Environmental Impact Assessment (EIA) Ordinance, Cap.499
Application for Variation of an Environmental Permit

Project: Shatin to Central Link – Hung Hom to Admiralty Section [SCL (HUH-ADM)]
(Application No. VEP- 467/2015)

Pursuant to Section 13(5) of the EIA Ordinance, we have amended the Environmental Permit (EP-436/2012/A). I attach the Environmental Permit as amended (No. EP-436/2012/B) for your use.

ENVIRONMENTAL PERMIT TO CONSTRUCT AND OPERATE
A DESIGNATED PROJECT

Figure 2: Marine Works for Shatin to Central Link - Hung Hom to Admiralty Section within Victoria Harbour
 圖 2: 沙田至中環綫 - 紅磡至金鐘段在維多利亞港內之海上工程

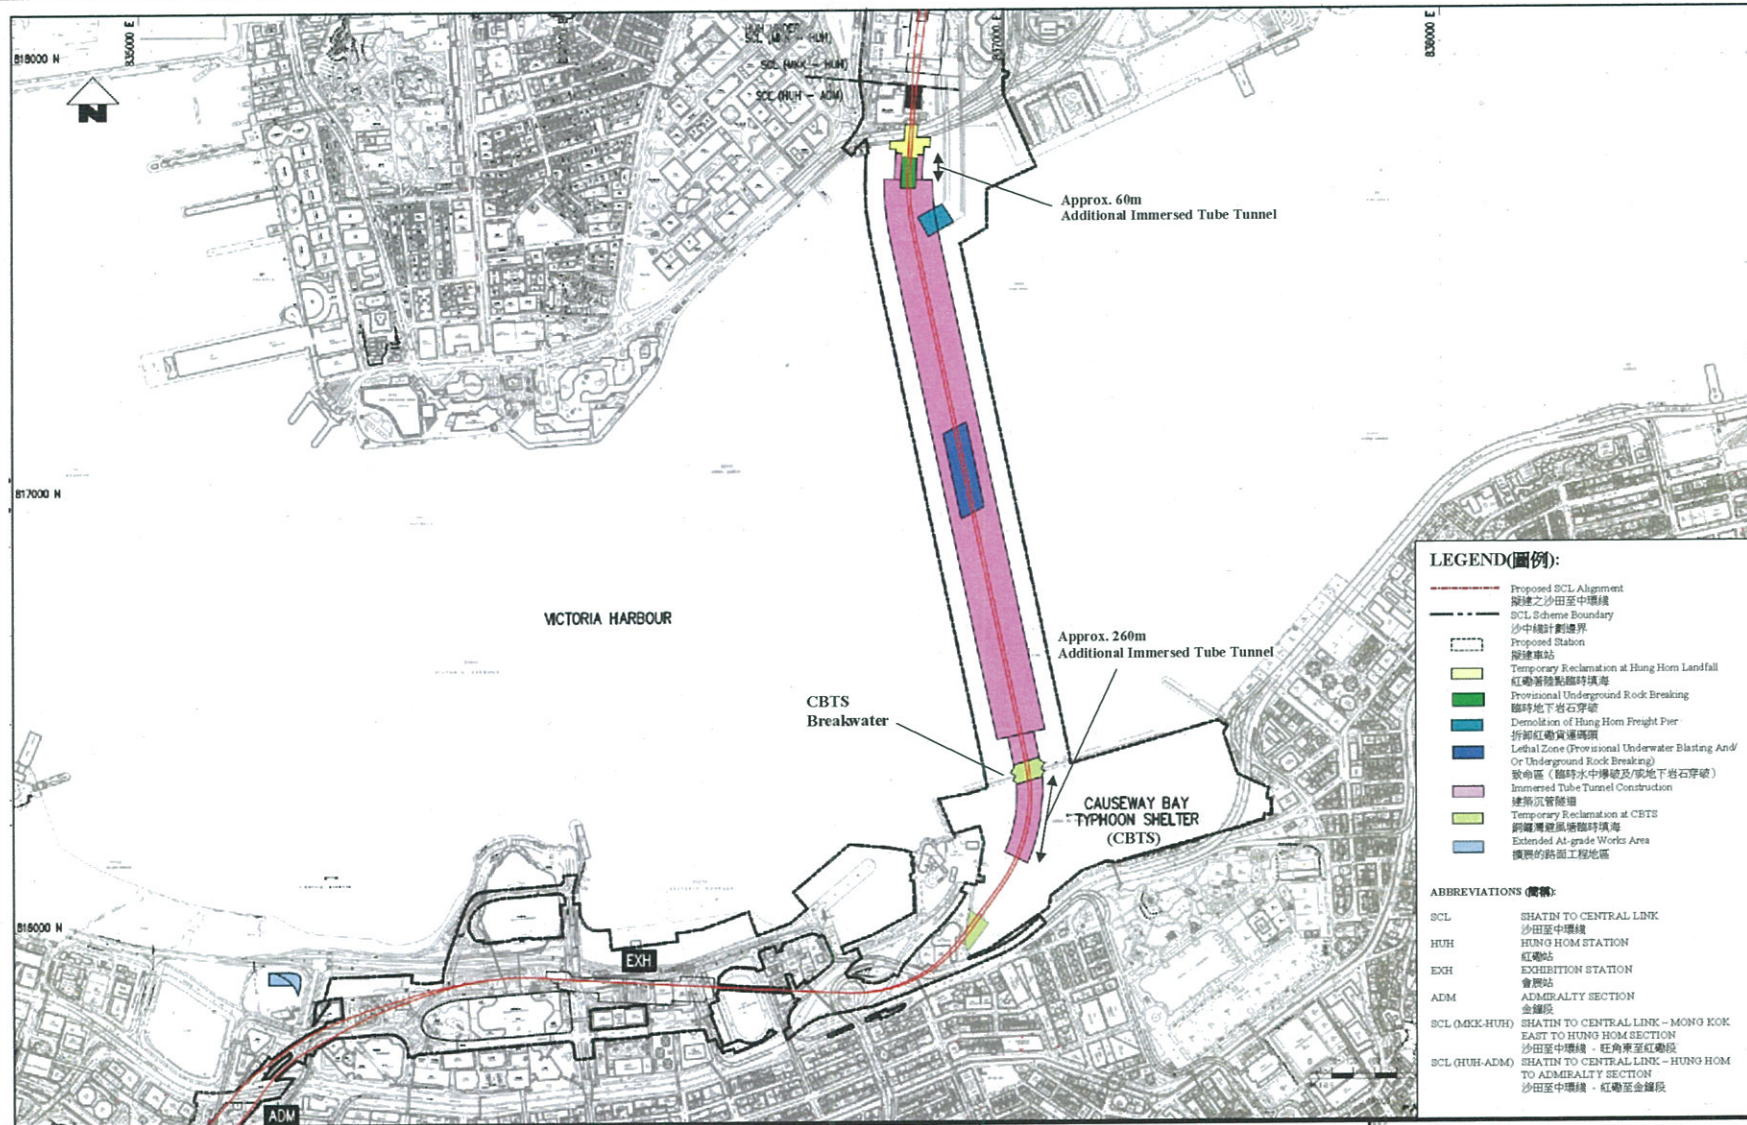
VEP-467/2015	18 February 2015 2015 年 2 月 18 日	Vary Condition 2.18, Condition 2.19, Condition 2.22 and Figure 2 in Part C to cover the extension of Immersed Tube Tunnel (IMT) at Hung Hom Landfall and within Causeway Bay Typhoon Shelter (CBTS). 更改環境許可證 C 部, 第 2.18, 第 2.19 及 2.22 項條件及圖 2 以於紅磡著陸點及銅鑼灣避風塘	19 March 2015 2015 年 3 月 19 日

- 2.16 To reduce the release of sediment and contaminant during temporary reclamation at Hung Hom Landfall, all excavation and dredging works shall be undertaken within cofferdam and there shall be no open dredging.
- 2.17 Silt curtains shall be installed to surround the works area to minimize the release of sediment due to removal and reinstatement of fender piles of Hung Hom Bypass and minor marine piling works as shown in Fig 2.

Figure 9: Location of Works Areas (Off-Site) – Kai Tak Barging Facility

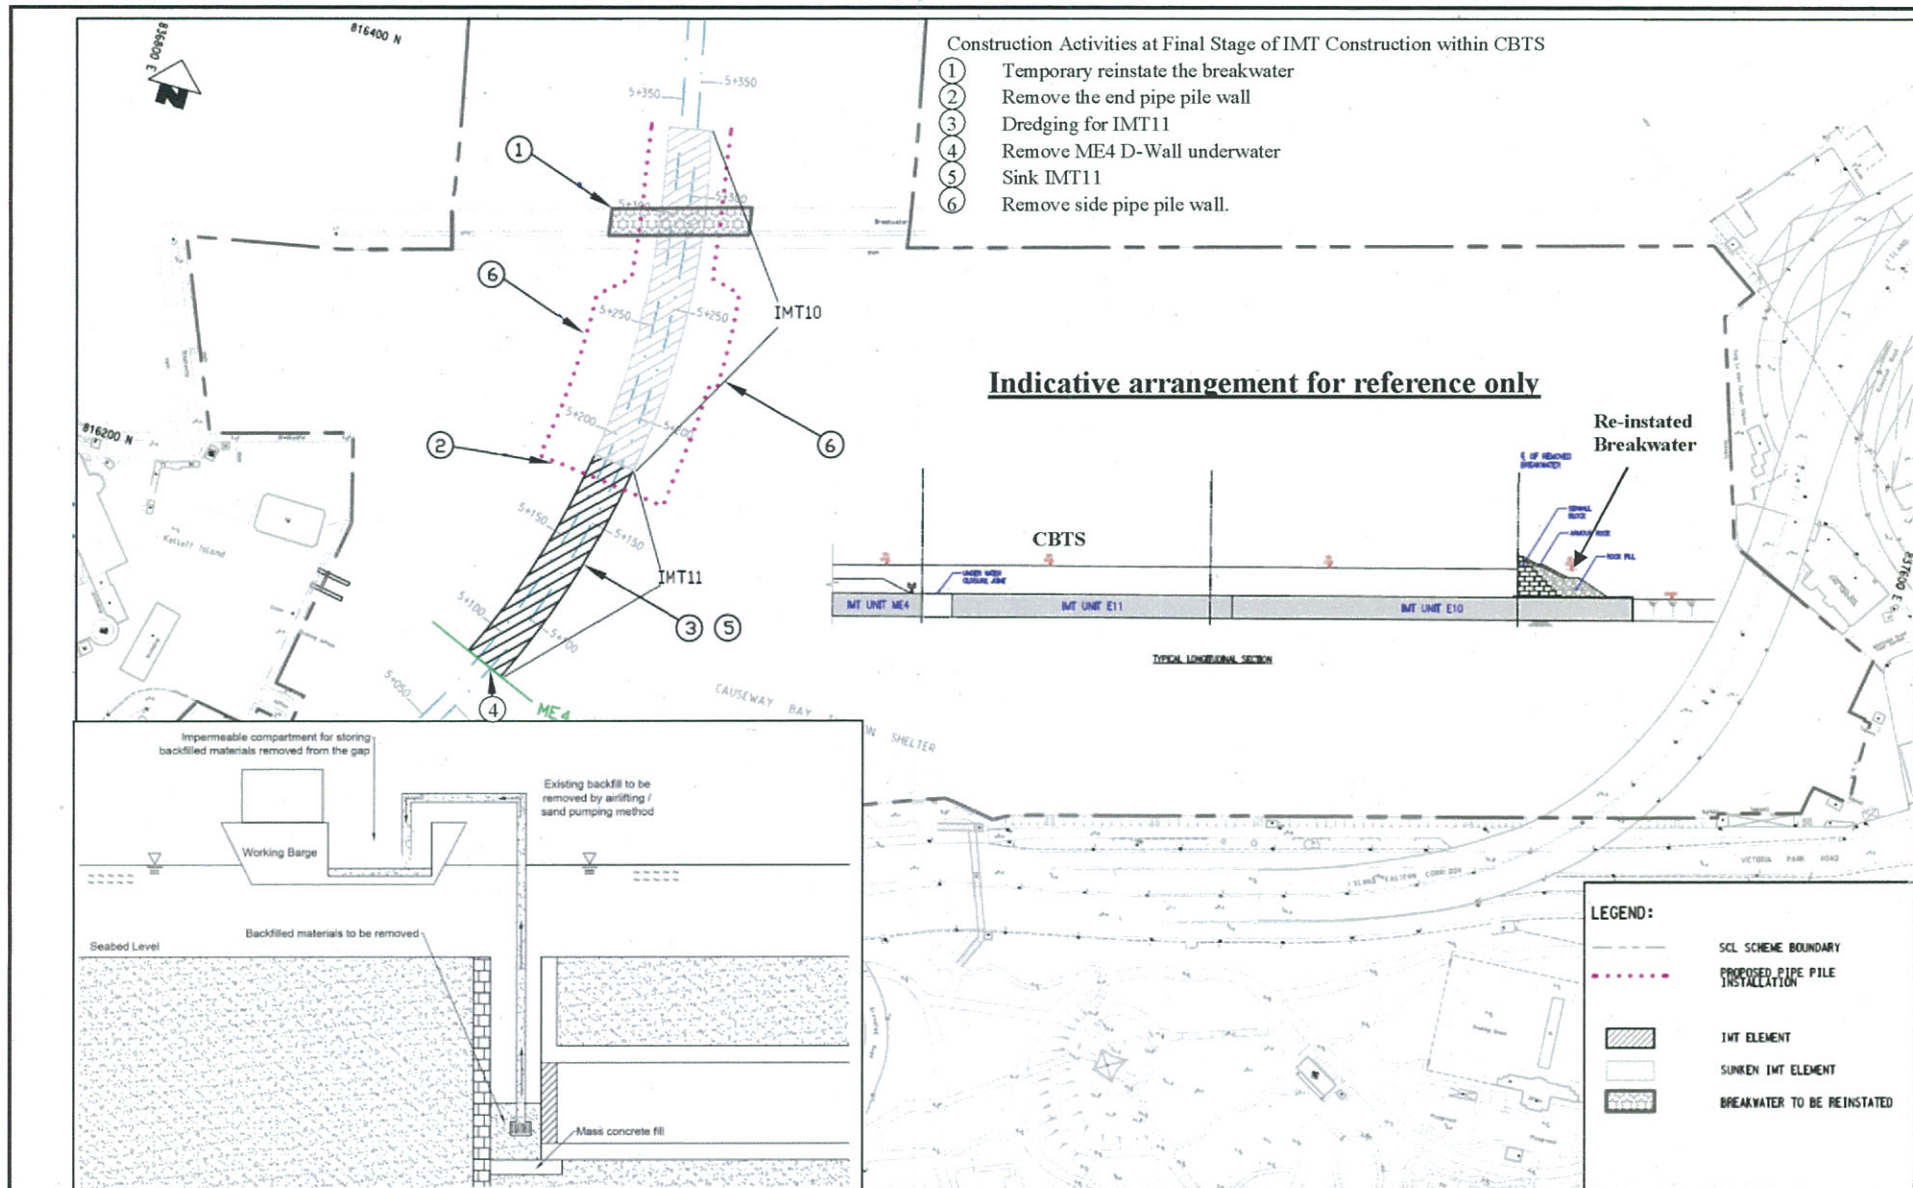
- 2.33 All construction and demolition materials (C&DM) arising from the Project shall be delivered to Kai Tak Barging Facility (KTBF) for reuse or disposal before the barging point at Wanchai ex-Public Cargo Working Area (ex-PCWA) becomes available. The location of KTBF is shown in Figure 9.
